1 Introduction

- 1.2 This Note seeks to address the comments made by AECOM acting on behalf of National Highways (NH), provided by email from Patrick Thomas on 28th March (attached in Appendix A), in relation to TT's M42 Jn10 TRANSYT Note, dated 8th March 2024, and the v7 TRANSYT model files also supplied on 8th March.

PJA Local Plan improvement Scheme for M42 Jn10

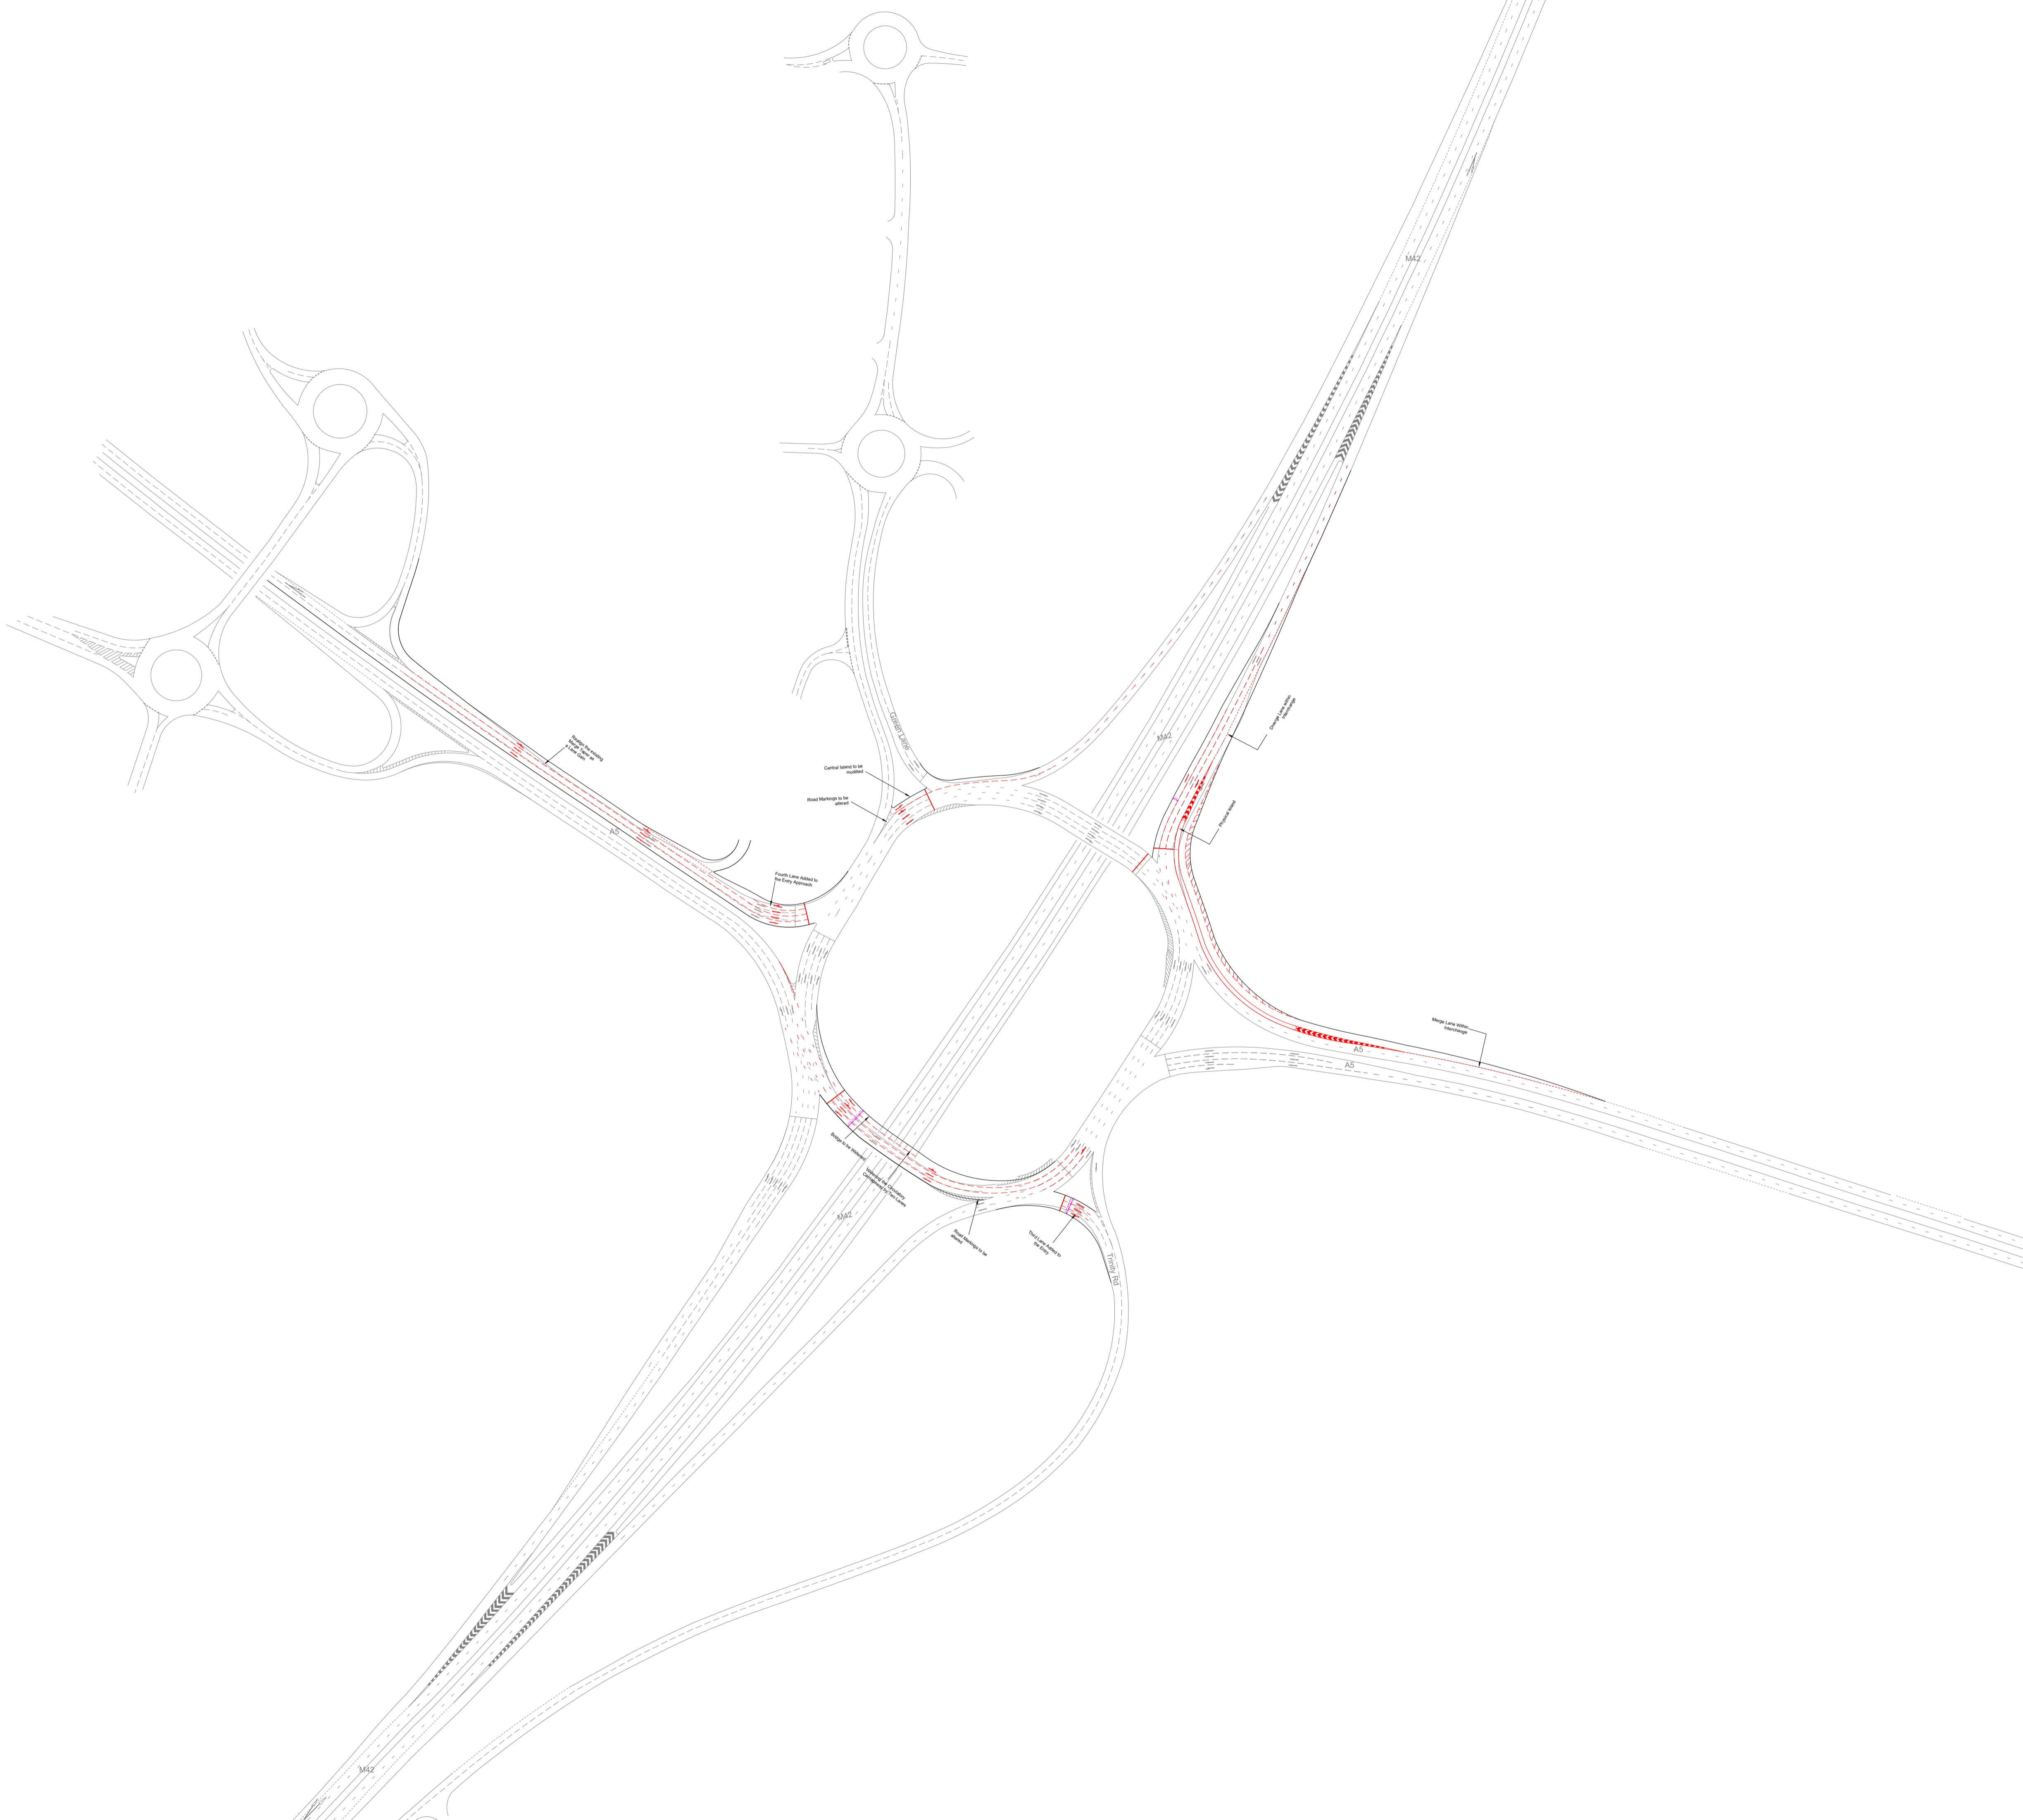
6.1 **NH/ AECOM comment summary:** *The applicant has compared their 2033 model results against a layout that includes local plan improvements at the roundabout (southern bridge widening and M42 southbound free flow left turn slip road). Is it clear when these improvements will be delivered, is the applicant conditioned to these improvements? The applicant has assessed the local plan year, rather than their opening year(s) (2026?), so it would be expected that these queue levels would be lower in a 2026 year of opening test. The applicant could model their year of opening (less traffic than tested currently) with associated infrastructure / mitigation if this was a sensible scenario in terms of planning / timing.*

6.3 The Local Plan TRANSYT model includes improvements at M42 Jn10 which are shown at PJA drawing 02853-01 Rev A attached at Appendix E. The Local Plan improvements for M42 Jn10 comprise three main elements i) widening the A5 eastbound approach to M42 Jn10, ii) a segregated left turn lane from M42 southbound off slip to the A5 eastbound, and iii) widening the southern overbridge to 4 lanes.

6.4 Our assessment shows that element i), A5 eastbound widening, is required in the Reference Case and Local Plan cases and it is proposed that these works will be delivered by a planning condition. Element ii), the segregated left turn lane is not required and is not included in the With Development Local Plan scenarios. Element iii) the southern overbridge widening, is required in the Local Plan case and the proposed development has a negligible impact on the

queues and delays on the bridge. The scale of the works needed to widen the bridge are considerable and this remains to be provided via the Local Plan. NH are investigating low cost improvements to M42 Jn10, one of which is widening the southern overbridge.
